CONDITIONS OF APPROVAL:

Open Issues: 14 These issues are currently being filtered

2017-03-02 Avondale Site Plan Full Set.pdf

2. D. Site Plan

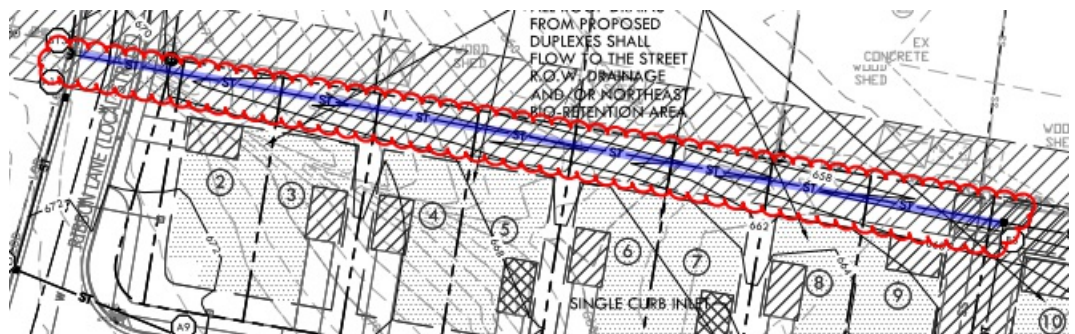
[lance.fittro@franklintn.gov](mailto:lance.fittro@franklintn.gov) The wall in question is scheduled to be removed in an upcoming COF Water Management project, with the date of removal yet to be determined. Should the Applicant desire the wall be removed prior to that by Water Management, the Applicant shall obtain a Right of Entry Agreement signed by the existing home owner prior to commencing work on the subject property. This comment to remain open as a reminder to Staff.
